## QUALITY ASSURANCE -- NON-CONFORMANCE REPORT

**Report No:** NCR-000912

**NCR #:** ZPMC-0874

**Reference Description:** ZPMC performed fabrication without following the "Weld Procedure Requirements for New Welds" by Rager/McQuaid

The weld is identified as BK008A3-002-026.

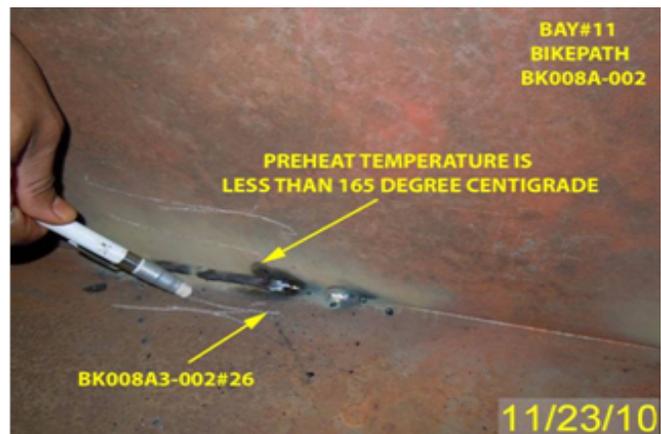
ZPMC welding personnel did not follow the "Weld Procedure Requirements for New Welds" by Rager/McQuaid

2f) Assembly: Preheat shall be applied in such a manner to provide a minimum temperature in the area of the weld of 165°C.

The tack welding process used was Shielded Metal Arc Welding (SMAW).

The area was being preheated using gas torch.

The weld is a fillet tack weld joining stringer plate (BKX14A) to deck plate (BKPL17A).

Contractor will provide the NDT report to prove the weld is acceptable.

Contractor provided the NDT report. The NDT report shows the weld is acceptable.
